Overview: Production error in version 1.0 harnesses; The immobilizer wire (orange/black) is in pin position #4 instead of pin position #5. Although an effort to correct the issue was made, some quantity of harnesses did get shipped before the issue was spotted. We are advising to inspect the harness BLADE connector before attempting to install harness or program the module. This issue is not known to affect the version 2 harnesses, which require no modification.

FTI-STP1: Notas de preparación y cobertura del vehículo

FTI-STP1: Notas de instalación y configuración

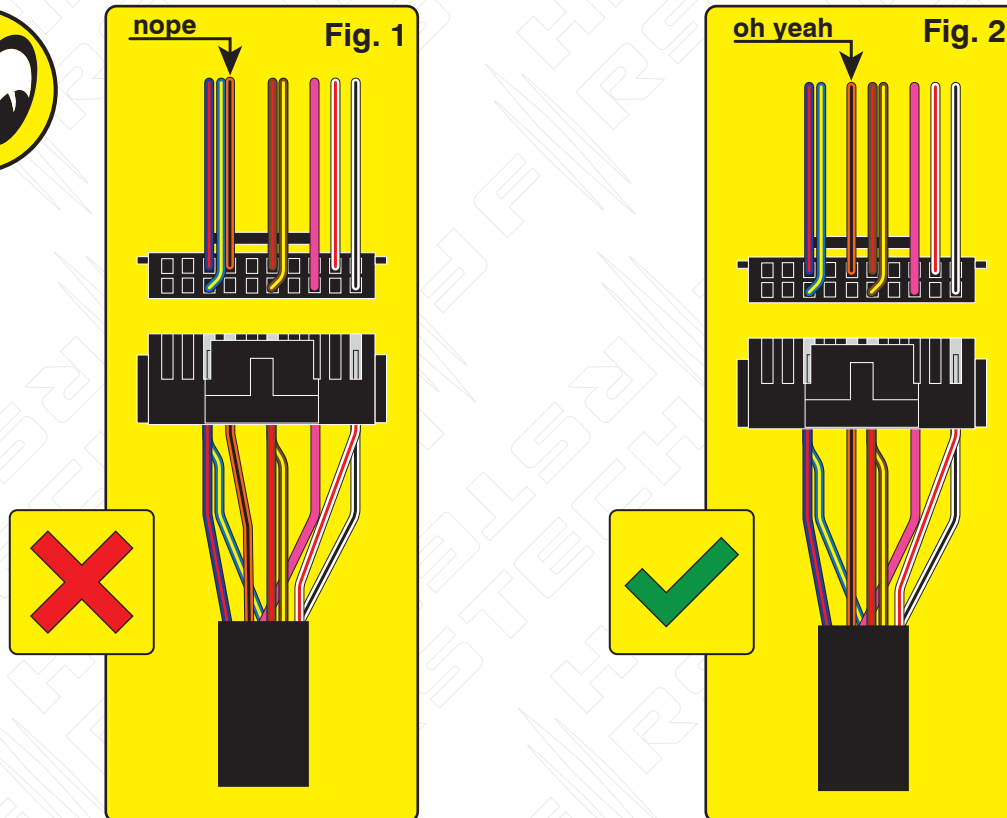
Issue: Module fails to program correctly to vehicle, does not allow the vehicle to be remote started.

Correction: Step 1.) Locate the orange/black wire and confirm whether it is positioned as illustrated in Fig. 1 or Fig. 2. If the wire is as illustrated in Fig.1, proceed with Step 2 through 5 and complete the repair procedure outlined, if the wire is as illustrated in Fig. 2, correction is not necessary, proceed with harness installation and module programming.

Step 2.) Using a pick, lightly depress the catch that secures the terminal in the housing then remove the wire and terminal from the housing.

Step 3.) Using a fine tip razor or utility knife, insert the blade beneath the terminal catch and raise it slightly, so that it can be reused to secure the terminal when reinserted into the BLADE connector housing.

Step 4.) Refer to Fig. 2 for correct position of the orange/black wire (next to brown/red) then reinsert the terminal, pressing lightly until the catch 'snaps' into place, securing the terminal in the connector housing.

Step 5.) The repair is complete, proceed with installation and programming.

MODIFICACIÓN REQUERIDA PARA APLICACIONES A/T, SÓLO CON ARNÉS v 1.0

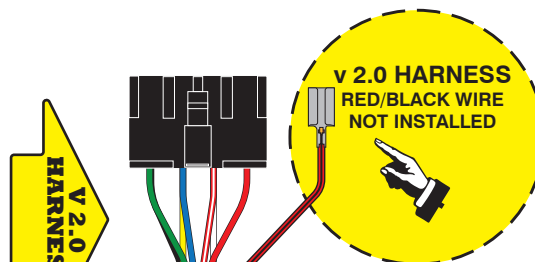
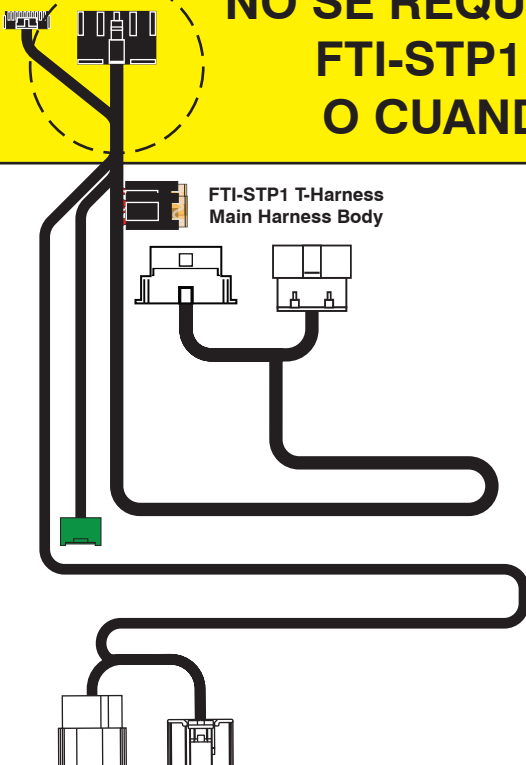
Descripción general: Las primeras versiones del arnés FTI-STP1 requieren modificaciones para aplicaciones de transmisión automática (AT), algunas del producto se pudo modificar antes del lanzamiento, pero una pequeña cantidad se lanzó sin modificaciones.

Problema: El arnés en T FTI-STP1 ha sido diseñado para ser compatible con A/T (transmisión automática) y M/T (manual), pero debido a un descuido en las primeras ejecuciones de producción, la selección se estableció por defecto en el modo M/T.

El uso de un arnés configurado para una aplicación M/T, en un vehículo equipado con A/T, podría provocar daños en el módulo del vehículo, se recomienda que el arnés vuelva al modo A/T antes de la instalación en vehículos equipados con transmisión automática.

Corrección: Localice el cable rojo/negro (+ embrague) proporcionado en el conector CN1 del conjunto del arnés principal. Corte el cable rojo/negro, ya sea al ras del conector CN1 o dejando suficiente cable expuesto para que pueda aislar y asegure los extremos del cable que quedan después del corte. Aísle cada uno de los extremos restantes del cable rojo/negro y asegúrelos para evitar cualquier posibilidad de cortocircuito. Si el cable rojo/negro ya ha sido desconectado, ninguna modificación adicional se requiere para aplicaciones A/T

NO SE REQUIERE MODIFICACIÓN CUANDO SE UTILIZA FTI-STP1 (v 1.0) ARNÉS EN APLICACIONES M/T, O CUANDO UTILICE EL ARNÉS FTI-STP1 (v 2.0)

Aplicaciones M/T: Arnés versión 2.0, el cable rojo/negro está pegado al arnés principal cuando se envía, y debe instalarse en el CN1 conector cuando está instalado.

Aplicaciones A/T: Deje el cable rojo/negro pegado al arnés, no es necesario para aplicaciones A/T
